To	From	Page 1 of 1
DISTRIBUTION	G.J. Gauck	Date February 21, 1995
Project Title/Work Order		EDT No. 610852
CLOSED OUT TANK 241-SY-101 DACS SYSTEM CHANGE REQUESTS #301-400.		ECN No.

Document Number:	WHC-SD-WM-CMD-004, REV 0
Document Title:	CLOSED OUT TANK 241-SY-101 DACS SYSTEM CHANGE REQUEST #301-400
Release Date:	3/14/95

This document provides a record closed out System Change Request #301-400 used during the development of the 241-SY-101 Hydrogen Mitigation Project Data Acquisition Control System.

HYDROGEN MITIGATION TEST PROJECT
System Change Request Status

Sheet 4 of 5

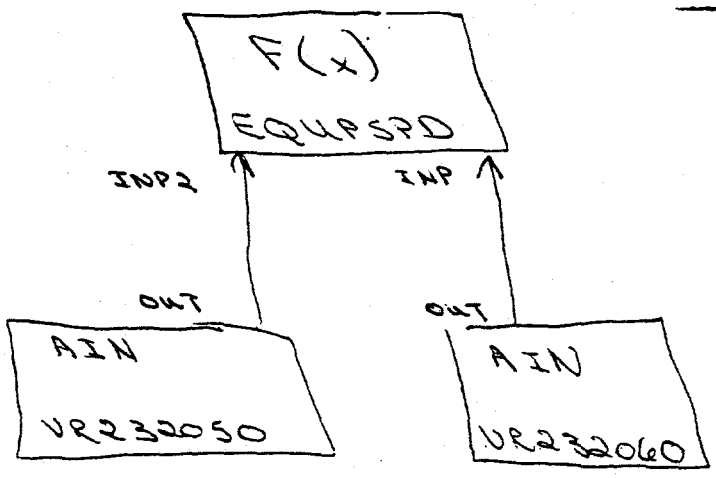
Reconnected Strategy Block EQUPSPD:

Sheet 2 of 3

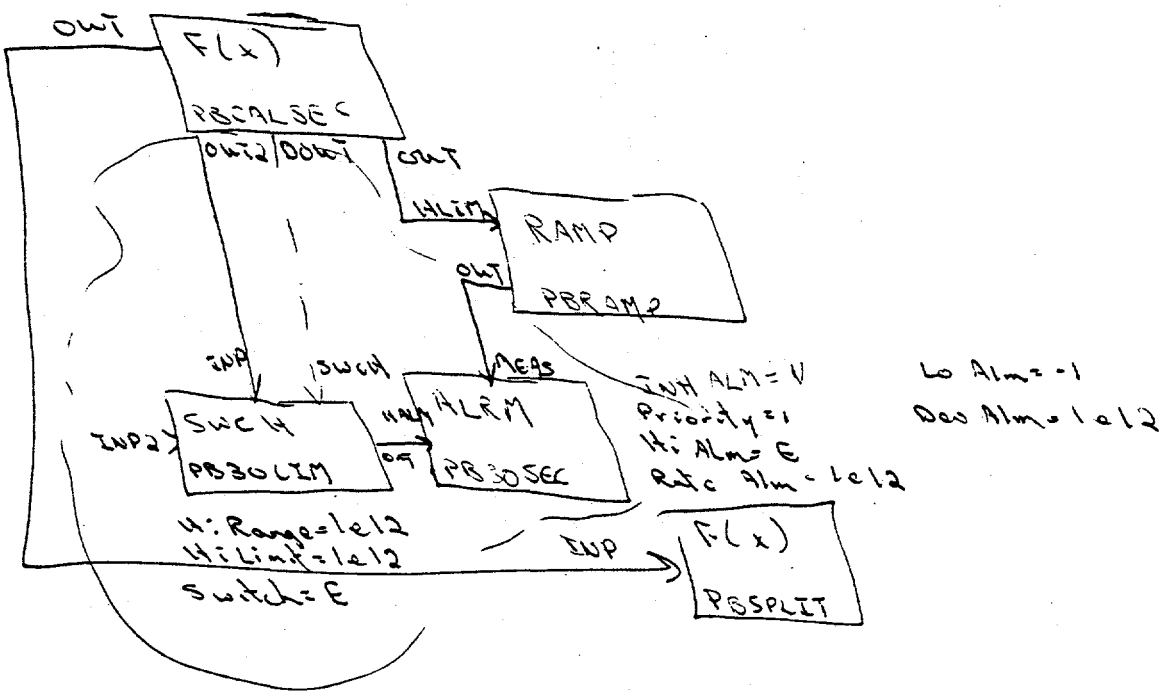
Added the following strategy blocks:

SCR No.: 318
Sheet 1 of

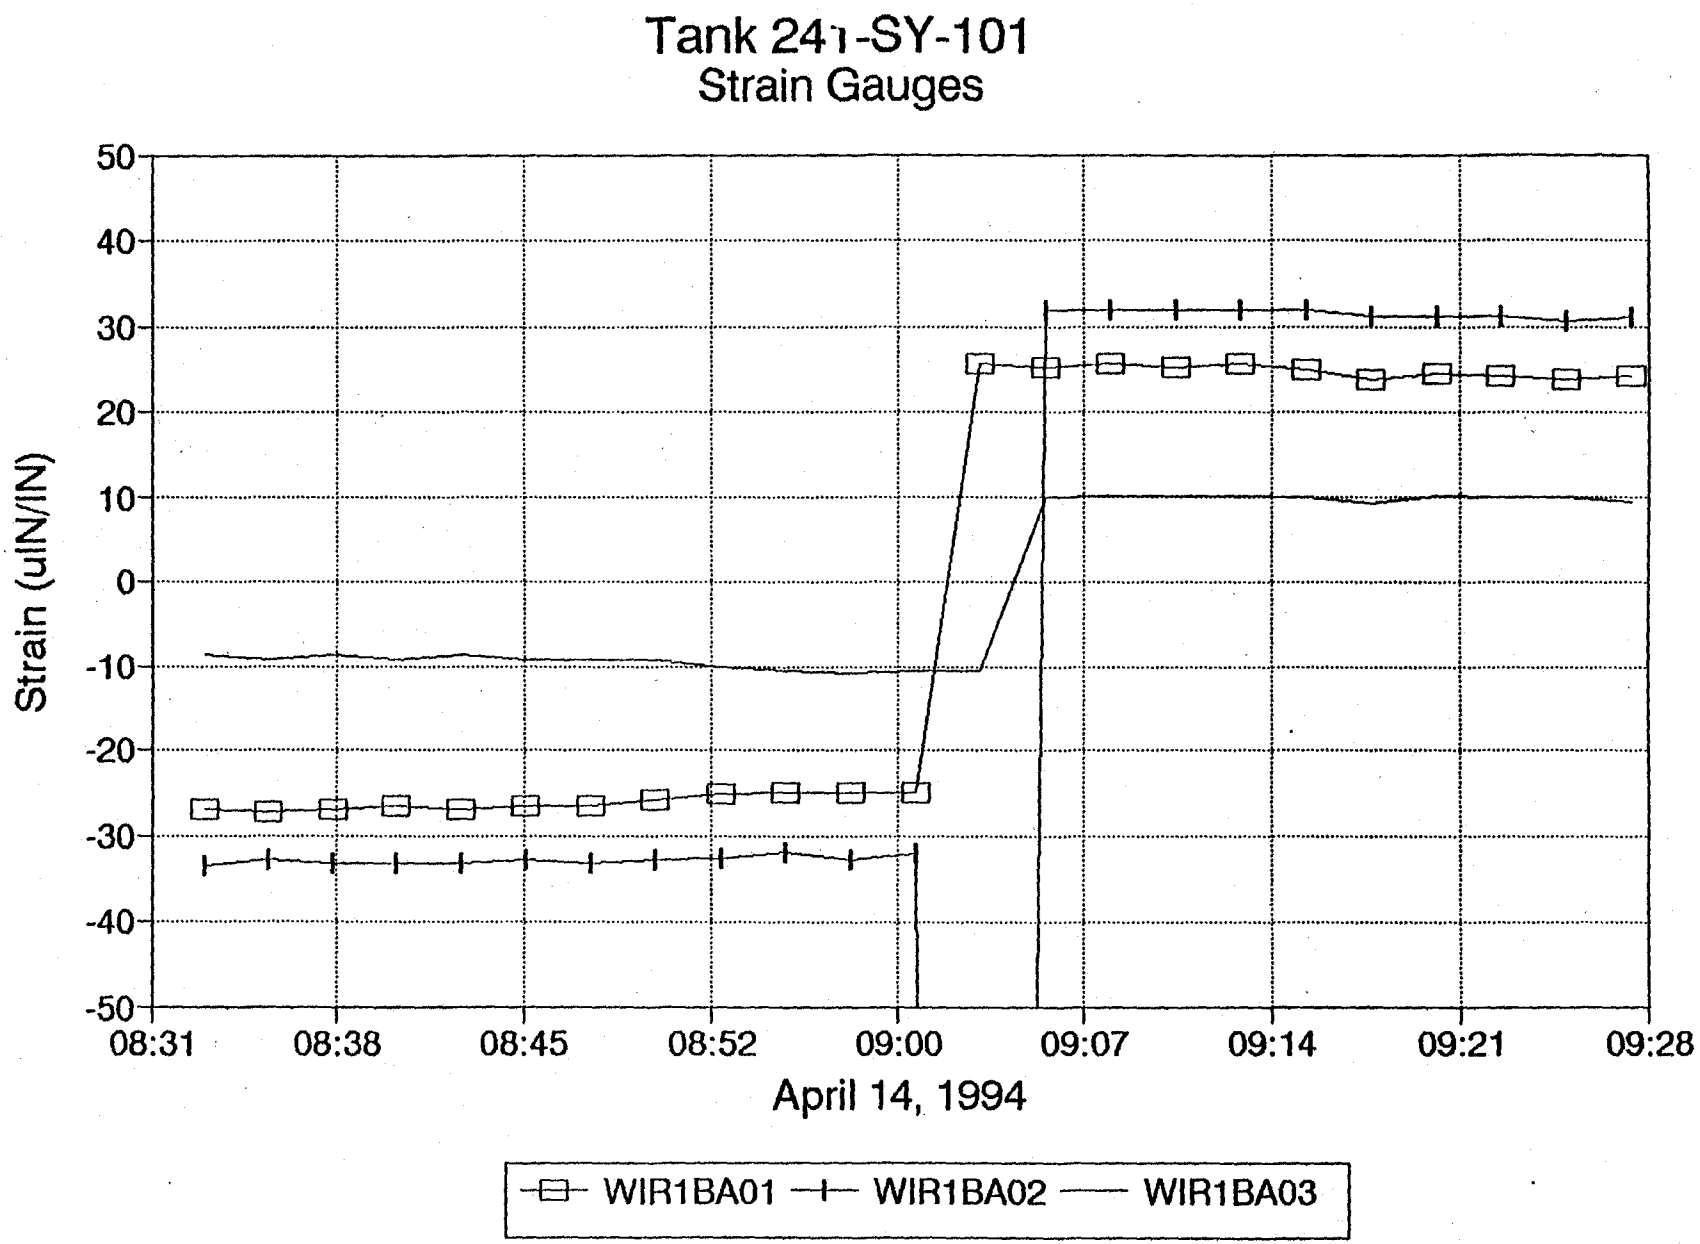
Tank 241-SY-101
Strain Gauges
Strain (uIN/IN)
50
40
30
20
10
0
-10
-20
-30
-40
-50
08:31
08:38
08:45
08:52
09:00
09:07
09:14
09:21
09:28
April 14, 1994
WIR1BA01
WIR1BA02
WIR1BA03

SCR No. 324, Page 8 of 41

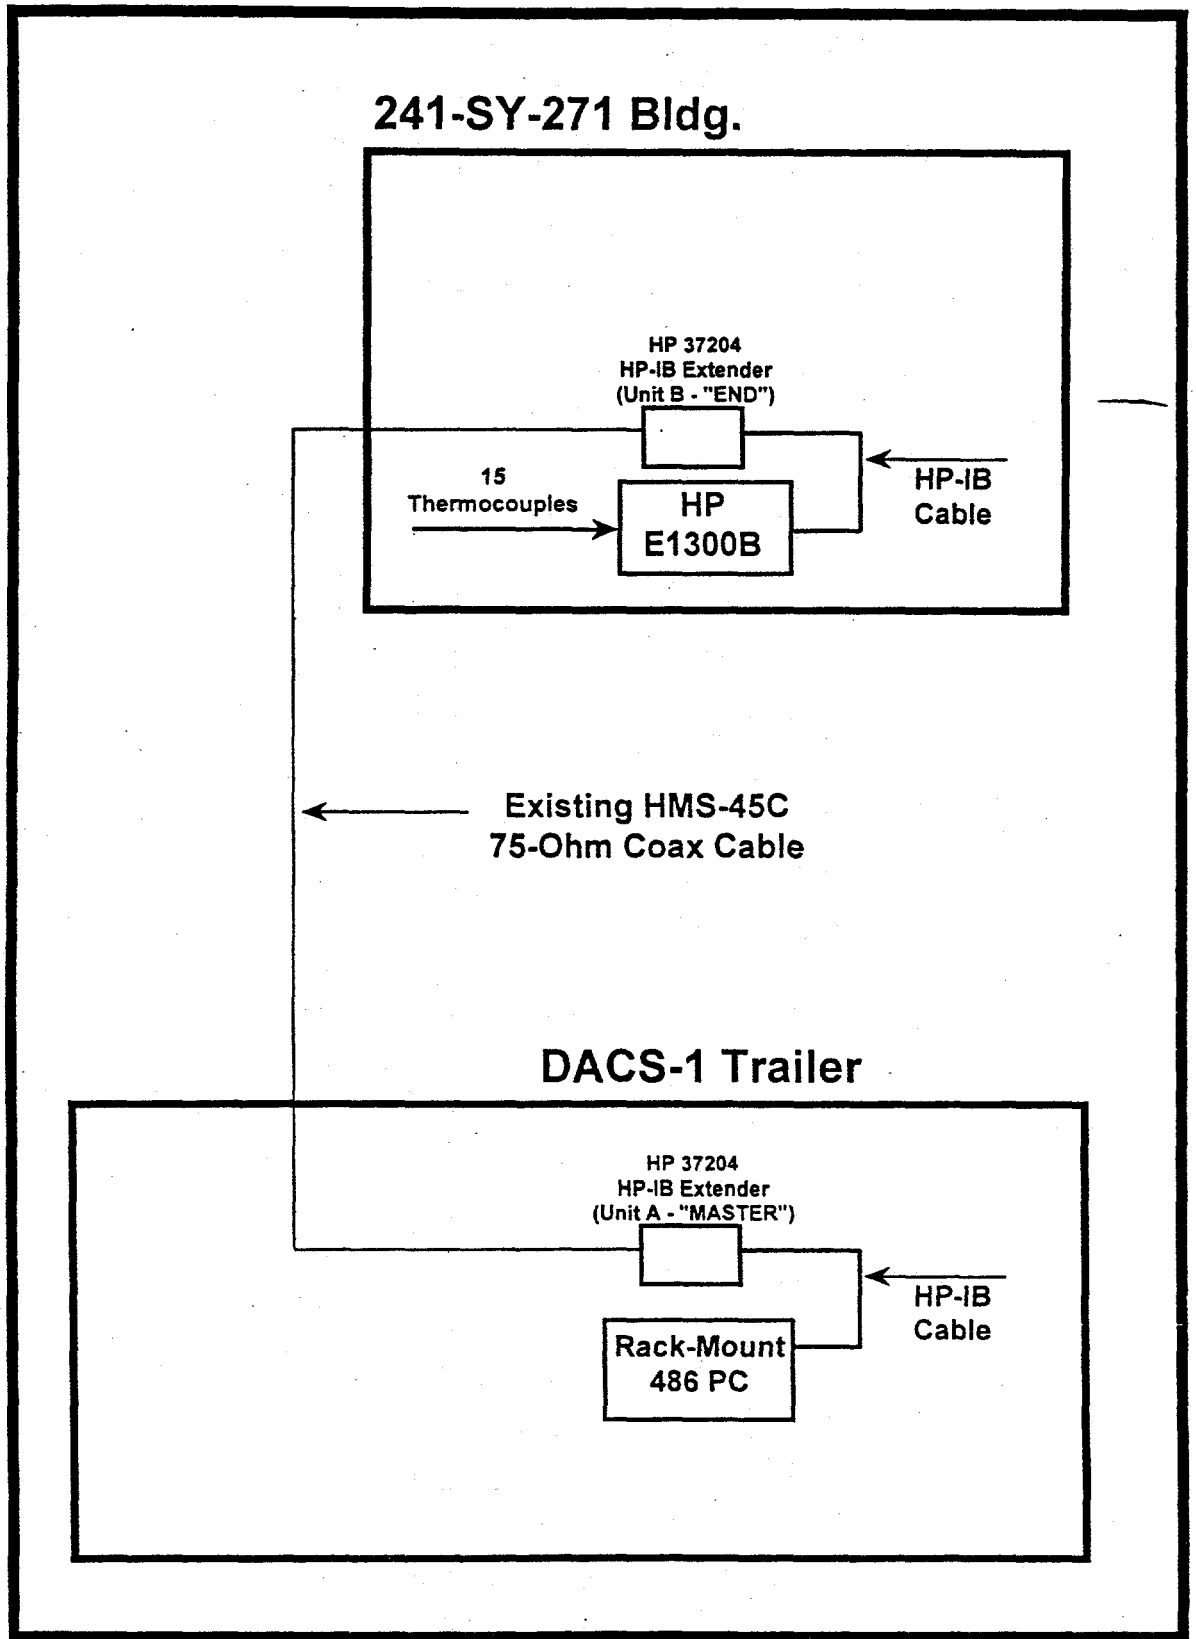
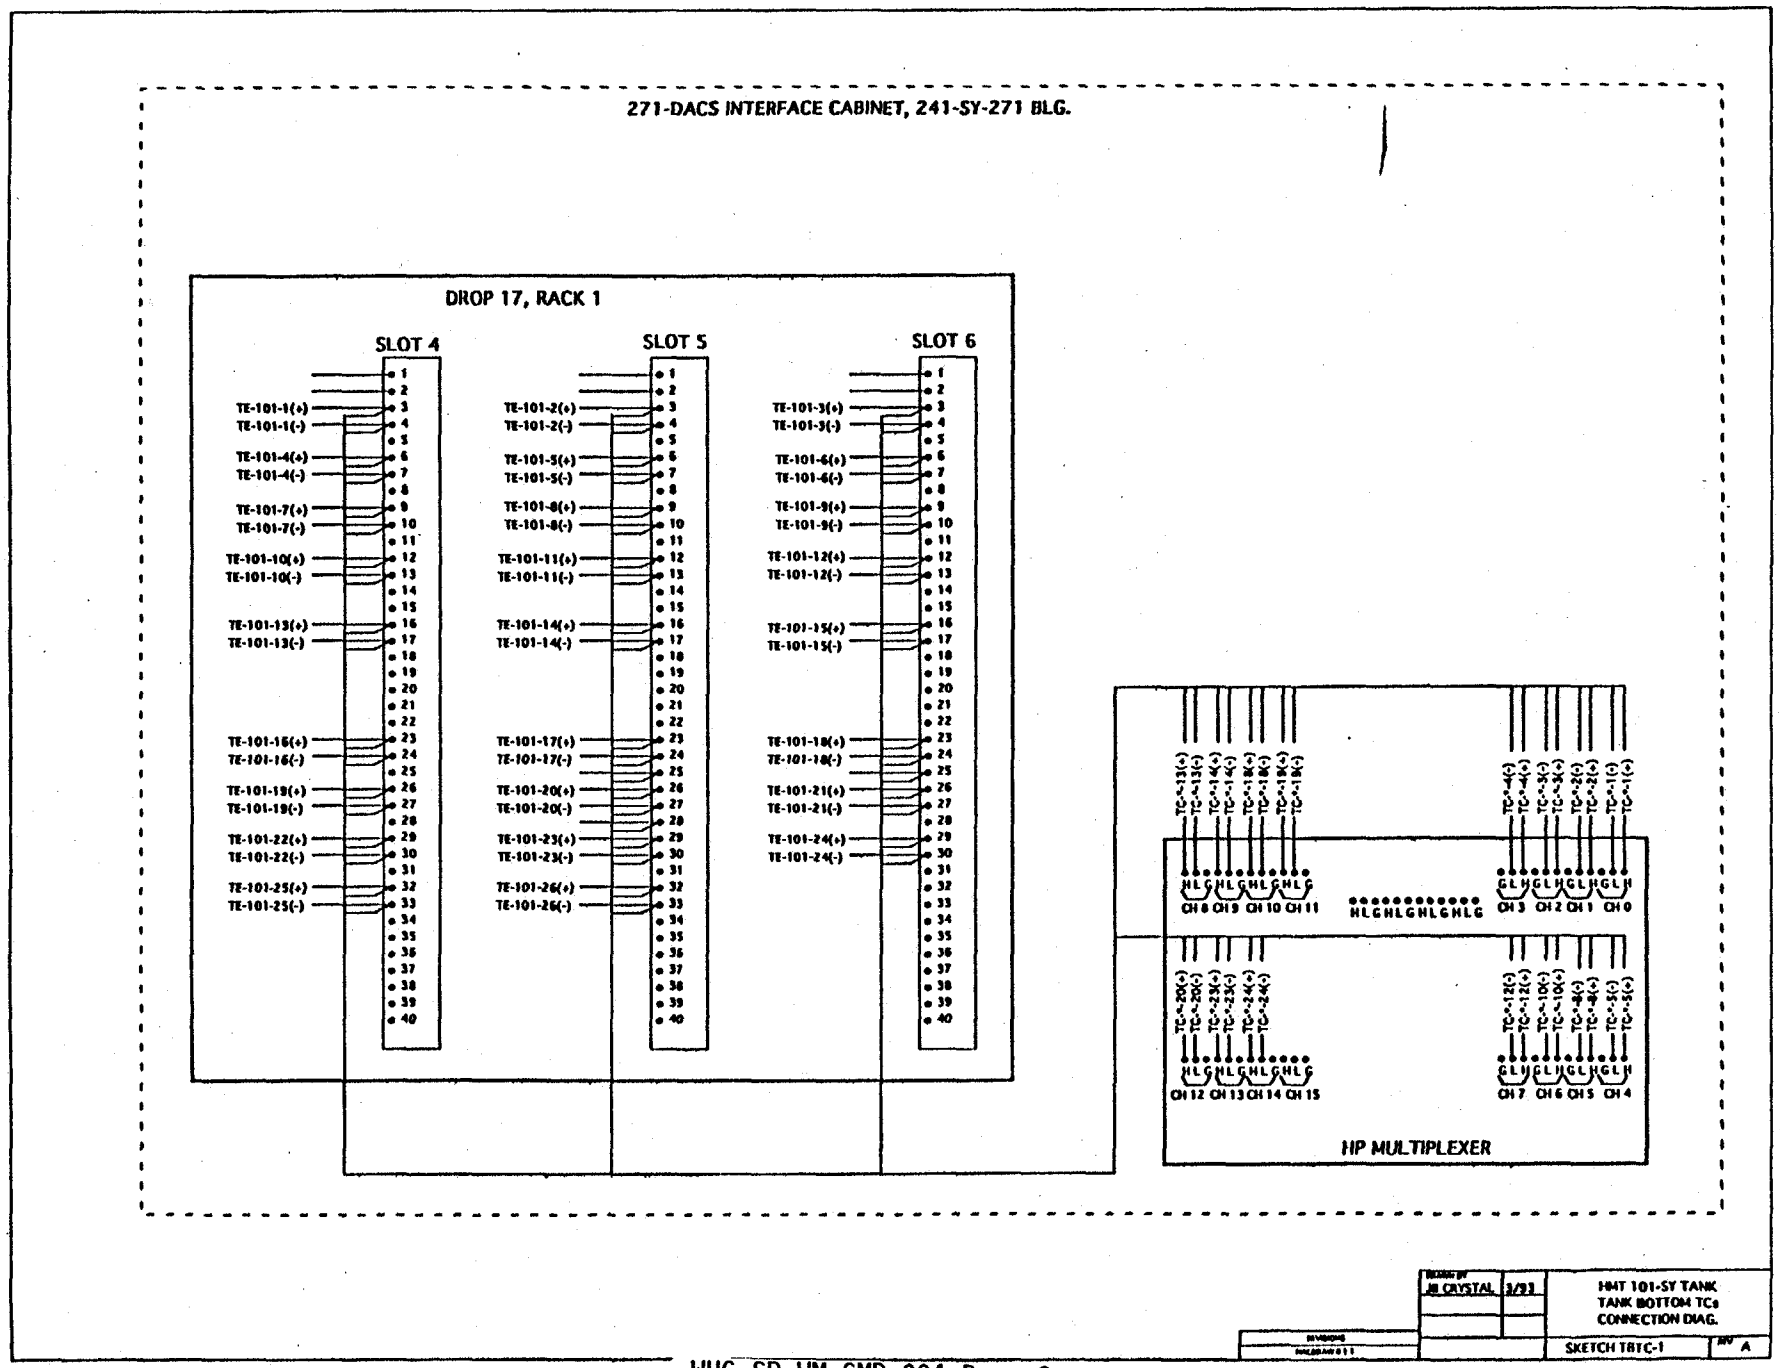
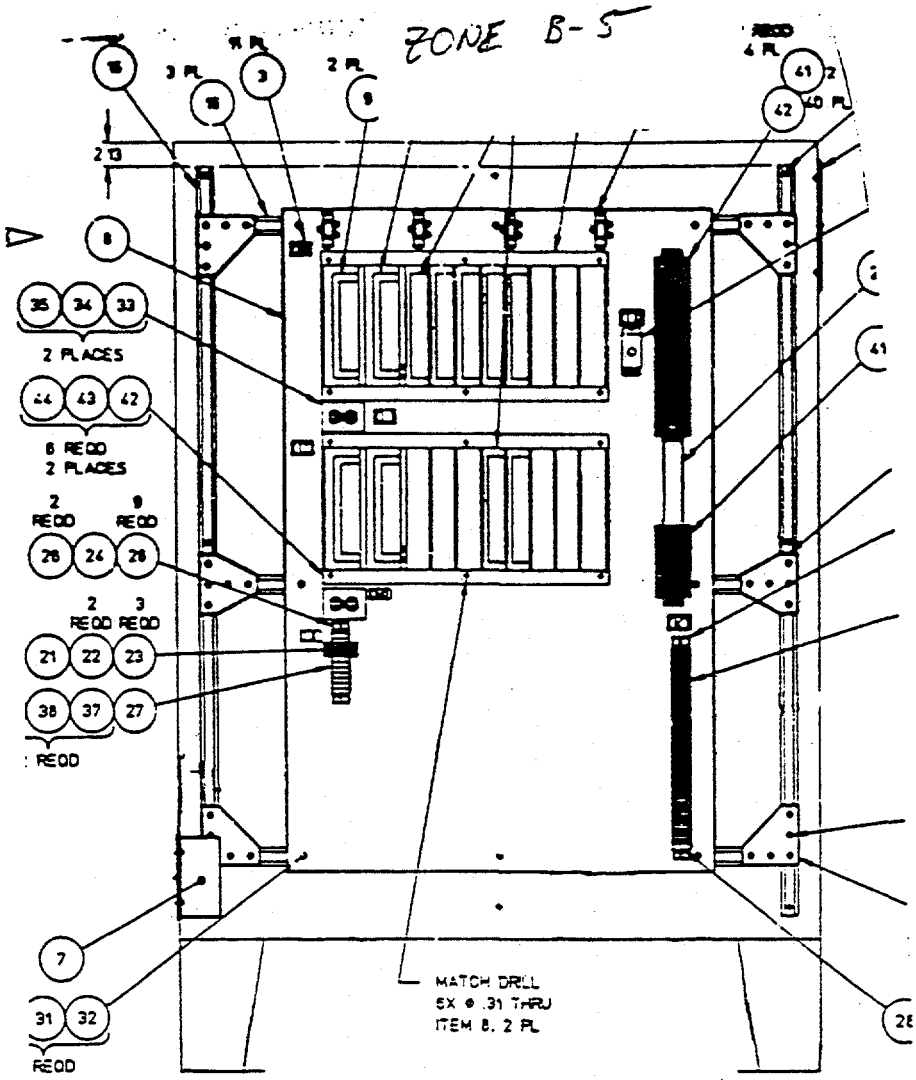
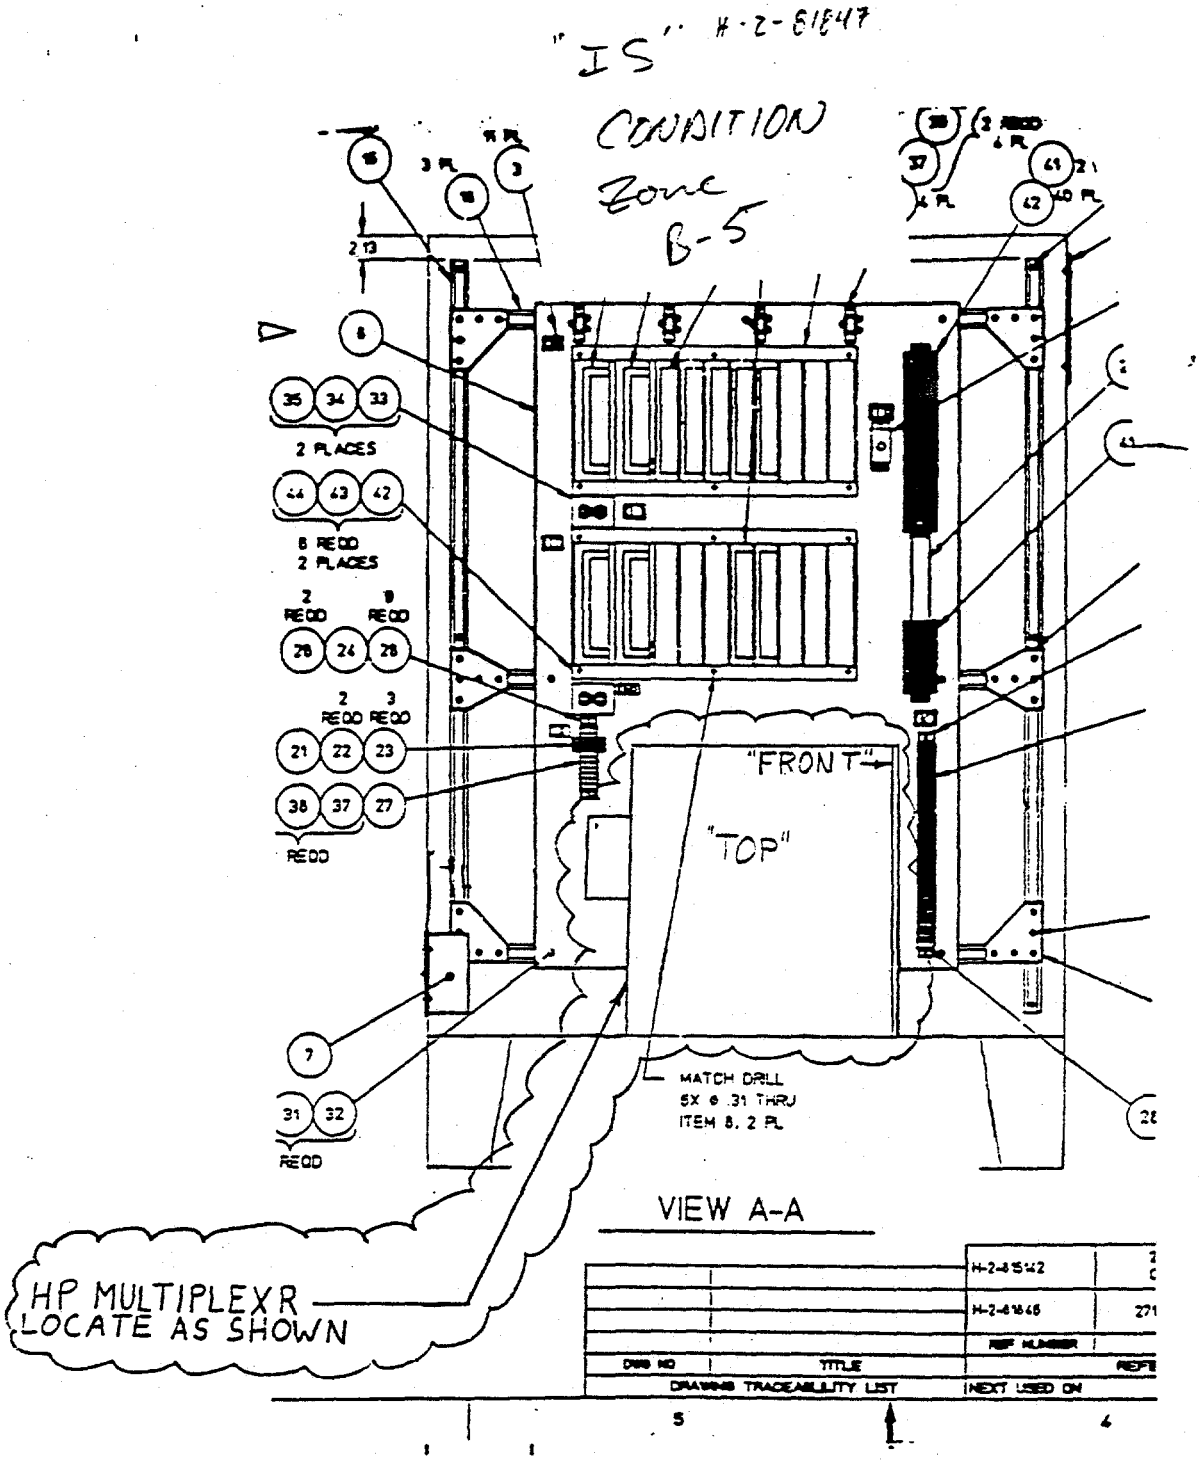
CONNECTION BLOCK DIAGRAM FOR TEMPORARY DATA LOGGER

Installation Notes:

1. Rest multiplexer in bottom of cabinet as shown.

2. Plug HP Multiplexer into available receptacle, RCPT2.

3. Use existing coaxial cable in bottom-left of cabinet to connect multiplexer communications to DACS.

Segment: 02 Object: P003 Network: #00061

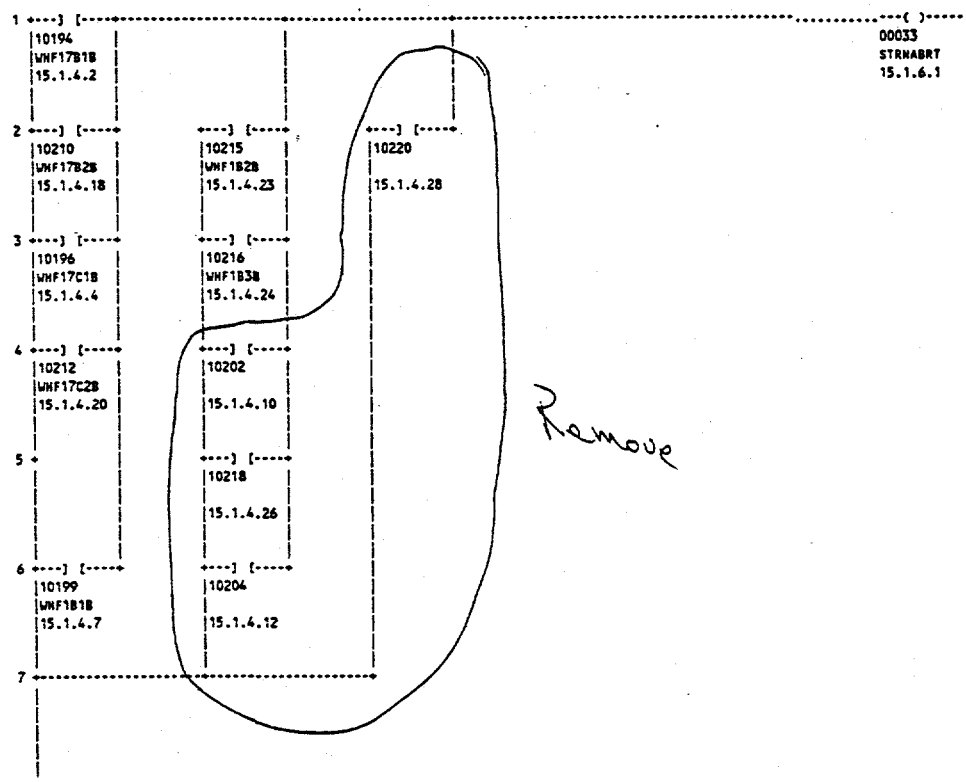
create composite aborts

00033 STRNABRT 15.1.6.1 HIGH FREQ STRN ABORT-8828 5V TTL G10C12 G15C2.1 02P003#061w1,* -( ) 02P003#063r3,1 -] I
